Zoning Board of Appeals
Tuesday, July 14, 2026, at 7:00pm
Gwinnett Justice and Administration Center
75 Langley Drive, Lawrenceville, GA 30046

ZONING BOARD OF APPEALS CASE REPORT

Case Numbers:	VAR2026-00030, 031, 032, and 033
Variance Requests:	Allow different exterior materials and colors from primary residence Allow accessory building to exceed the height of the primary residence To exceed maximum cumulative square footage of accessory buildings Allow prohibited exterior materials
Zoning District:	R-100 (Single-Family Residence District)
Address:	6245 Sycamore Road
Map Number:	R7350 021
Site Area:	6.97 acres
Applicant:	Melody Glouton, Andersen, Tate, & Carr P.C.
Owner:	Ivan Polukhin
Commission District:	District 4 – Commissioner Holtkamp
Staff Recommendation:	DENIAL

Site plan (accessory buildings highlighted and labeled A, B, C, and D)

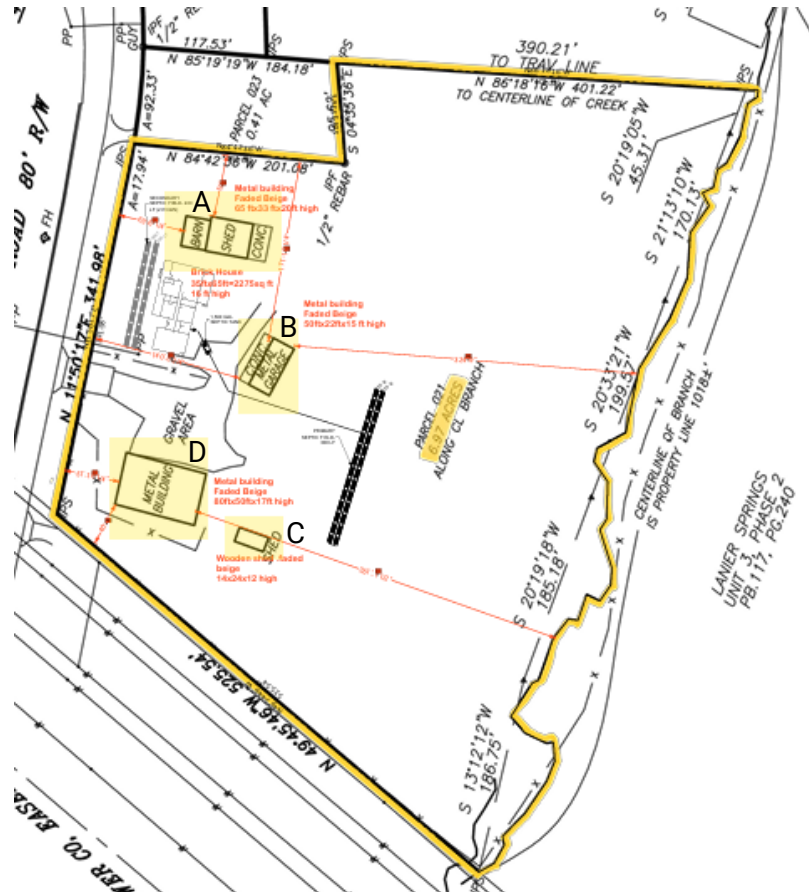
The applicant is requesting to retain four metal accessory buildings. The accessory buildings were constructed without permits, and a notice of violation was issued in March 2024. The total cumulative square footage of accessory buildings is approximately 7,245 square feet, which exceeds the maximum allowed square footage of 1,137 square feet by 6,108 square feet. Accessory building A is 20 feet tall and accessory building D is 17 feet tall, both exceeding the 16-foot height of the principal dwelling. All four accessory buildings (A, B, C, and D) do not match the colors or materials of the principal dwelling and have prohibited metal exterior building materials.

The applicant is seeking to retain four accessory buildings that do not comply with the size, height, design, and architectural standards established by the UDO. Although several of the accessory buildings have existed on the property since the early to mid-1990s, none of the buildings obtained the required permits or certificates of completion.

The 1992 variance approval (ZV920124), authorized the construction of one accessory building prior to the construction of the principal dwelling and specifically prohibited the accessory building from exceeding the size of the future principal dwelling. Three additional accessory buildings were constructed without permits. The UDO regulates the size, height, and design of residential accessory buildings to mitigate adverse effects on neighboring residential properties. The large metal garages and accessory buildings are inconsistent with the intent of the UDO. All of the surrounding properties are zoned for single-family residential use, and approval of the request would be incompatible with the surrounding area and neighborhoods. Additionally, the site does not exhibit any unique physical or topographical characteristics that would necessitate the need for any of the requested variances. Therefore, strict adherence to a provision in the UDO does not create a hardship, and approval would circumvent the purpose or intent of the Unified Development Ordinance.

Based upon the findings and conclusions herein, the Department of Planning and Development recommends **DENIAL** of the variance requests.

Site plan (proposed reduced setback in highlighted in yellow)

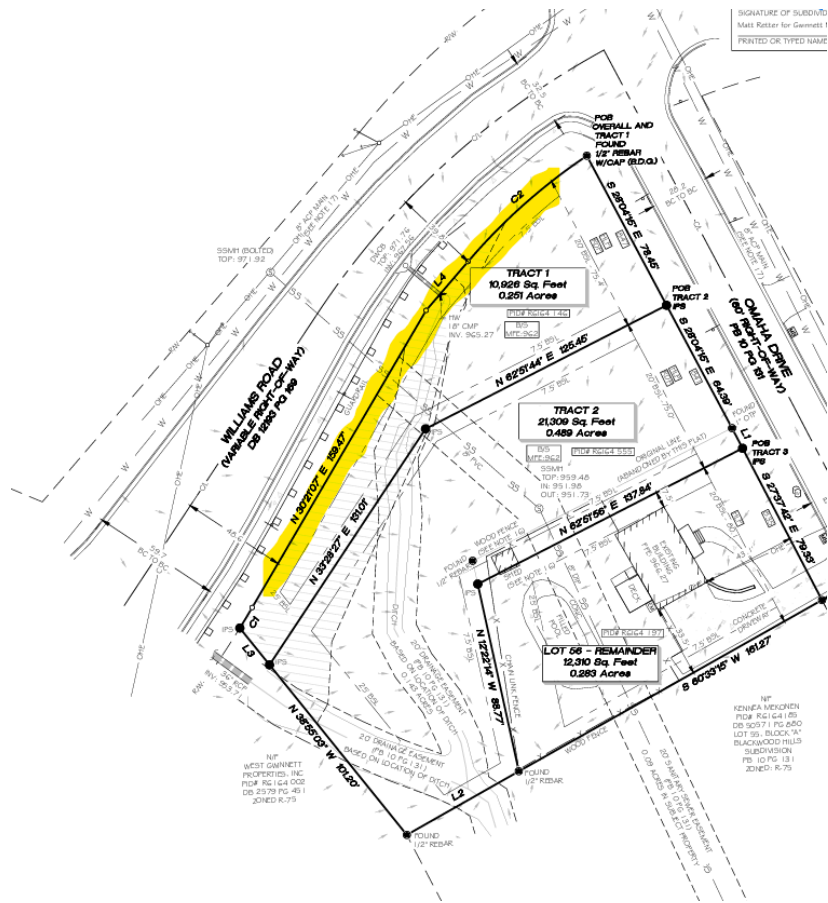
The applicant is requesting a variance to reduce the front setback of 20 feet by 12.5 feet, resulting in a 7.5-foot-wide setback and to not provide the 40-foot-wide setback including a 10-foot-wide landscaped strip adjacent to the right-of way from the side of the residence.

The applicant is requesting a variance to reduce the front setback to 7.5 feet in one of the front yards on a corner lot. The property is currently undeveloped and has an active exemption plat application proposing to create three residential lots (PLAT2026-00127). Due to its corner lot configuration, the property contains frontage along both Williams Road and Omaha Drive, resulting in increased setback requirements that further constrain the buildable area of the site. The property benefits from existing screening located in the right-of-way along Williams Road, including mature trees, vegetation, and a guardrail, which provide a visual buffer between the roadway and the proposed development. The existing features would significantly limit the visibility of any proposed residence along Williams Road. Therefore, approval would not circumvent the purpose or intent of the Unified Development Ordinance.

Based upon the findings and conclusions herein, the Department of Planning and Development recommends **APPROVAL WITH CONDITIONS** of the variance request, with the following condition:

1. The site shall be developed in general conformance to the site plan dated received May 6, 2026, with revisions required by the Unified Development Ordinance, subject to the review and approval of the Department of Planning and Development.

Site plan (proposed detached garage highlighted)

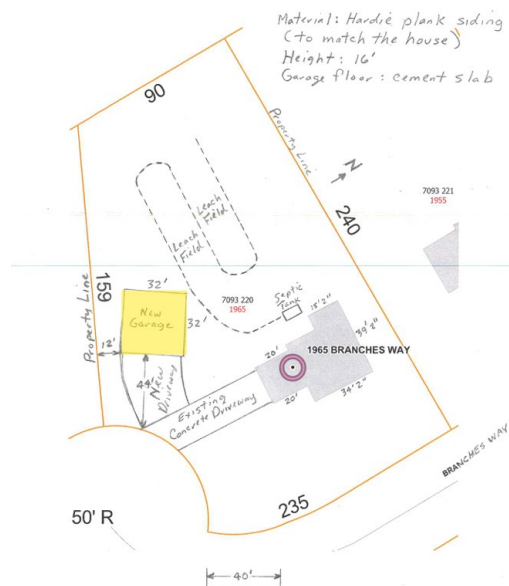
The applicant is requesting to construct a 1,024 square-foot detached garage in the front yard area.

Based upon the findings and conclusions herein, the Department of Planning and Development recommends **APPROVAL WITH CONDITIONS** of the variance request, with the following conditions:

1. The property shall be developed in general conformance to the site plan dated received May 13, 2026, with revisions required by the Unified Development Ordinance, subject to the review and approval of the Department of Planning and Development.

Proposed dumpster enclosure location (highlighted yellow)

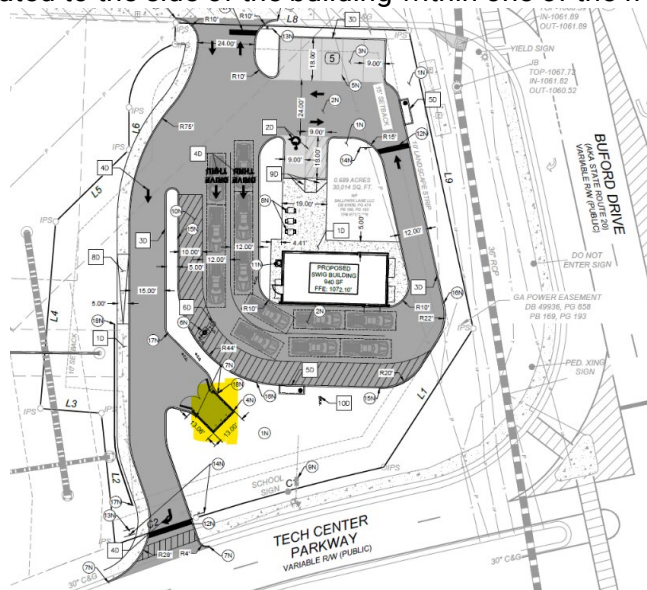
The applicant is proposing a dumpster enclosure in the front yard of a corner lot. The proposed dumpster enclosure is located to the side of the building within one of the front yards.

Based upon the findings and conclusions herein, the Department of Planning and Development recommends **APPROVAL WITH CONDITIONS** of the variance request, with the following condition:

1. The property shall be in general conformance to the site plan and dumpster enclosure elevations dated received February 13, 2026, with revisions required by the Unified Development Ordinance, subject to the review and approval of the Department of Planning and Development.

Site plan (pool and deck highlighted)

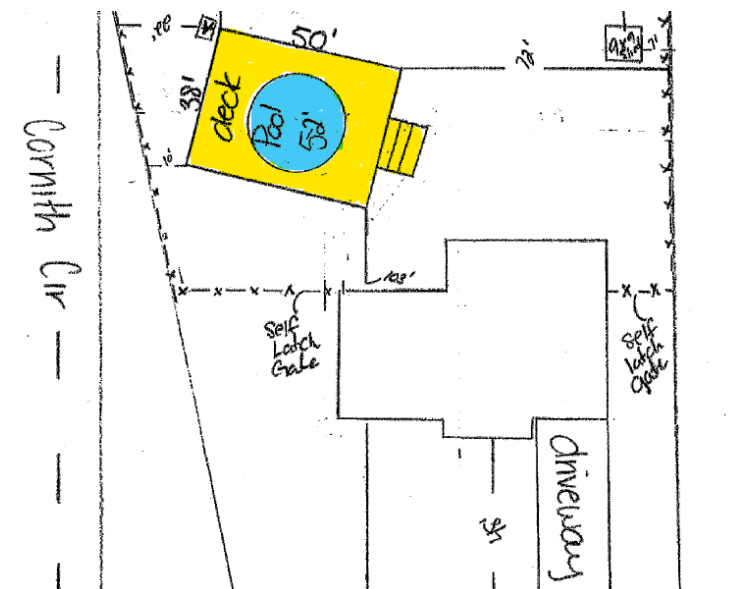
The applicant is requesting to retain an above-ground pool and deck in the front yard.

Based upon the findings and conclusions herein, the Department of Planning and Development recommends **APPROVAL WITH CONDITIONS** of the variance request, with the following condition:

1. The property shall be in general conformance to the site plan dated received May 19, 2026, with revisions required by the Unified Development Ordinance, subject to the review and approval of the Department of Planning and Development.

Site plan (compacted gravel driveway highlighted)

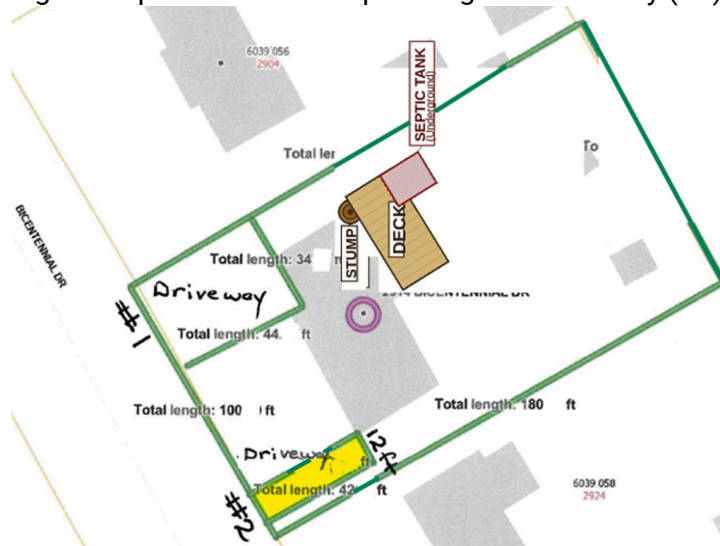
The applicant is requesting to keep the denied compacted gravel driveway (#2).

Based upon the findings and conclusions herein, the Department of Planning and Development recommends **DENIAL** of the variance request.

Site plan (accessory building highlighted)

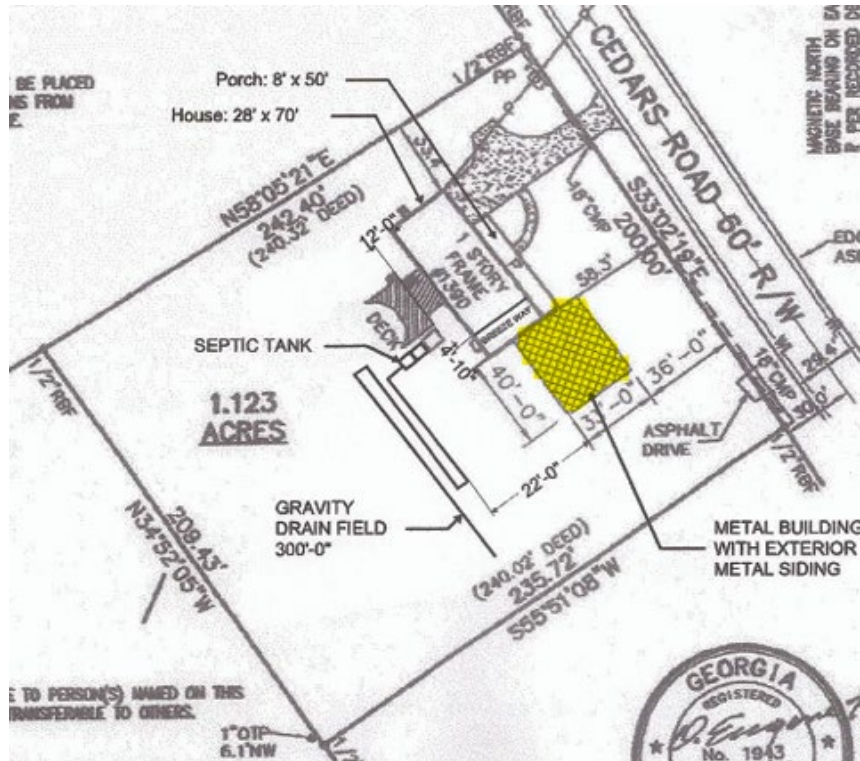
The applicant is requesting four variances to retain a 1,320-square-foot, 12.2-foot-tall metal accessory building that is partially located within the front yard.

Based upon the findings and conclusions herein, the Department of Planning and Development recommends **APPROVAL WITH CONDITIONS** of the variance requests, with the following conditions:

1. The property shall be in general conformance to the site plan dated received June 1, 2026, with revisions required by the Unified Development Ordinance, subject to the review and approval of the Department of Planning and Development.
2. A certificate of completion shall be obtained for the accessory building within 120 days.

Site plan (parking area for the trailer highlighted)

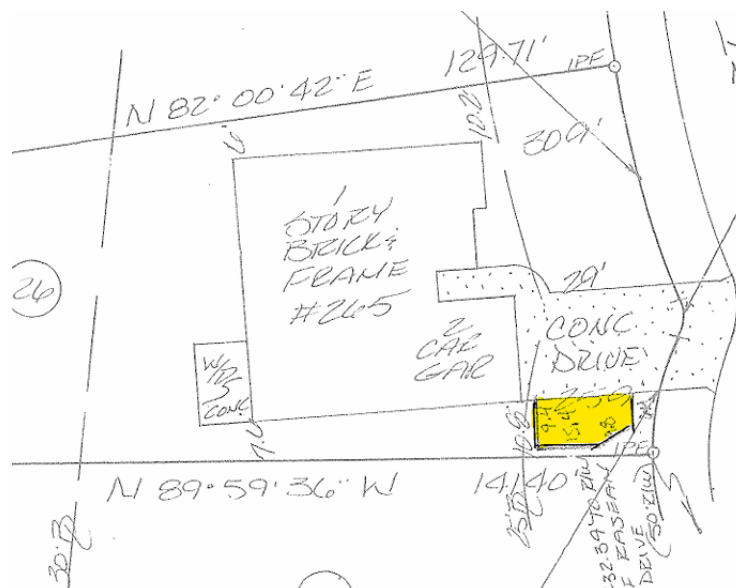
The applicant is requesting to retain a trailer parked in the front yard instead of the side or rear yard.

The applicant is requesting to retain a non-motorized vehicle in the front yard. Front yards are required in single-family zoning districts to provide open space, create a buffer between residences and the roadway, and enhance the overall aesthetic character of residential neighborhoods. The storage of a non-motorized vehicle does not meet the intent of a residential front yard. The property is zoned R-60, which allows for smaller lots and does not provide adequate space for parking non-motorized vehicles in the front yard without creating adverse impacts on neighboring properties. Therefore, strict adherence to a provision in the UDO does not create a hardship, and approval would circumvent the purpose or intent of the Unified Development Ordinance.

Based upon the findings and conclusions herein, the Department of Planning and Development recommends **DENIAL** of the variance request.
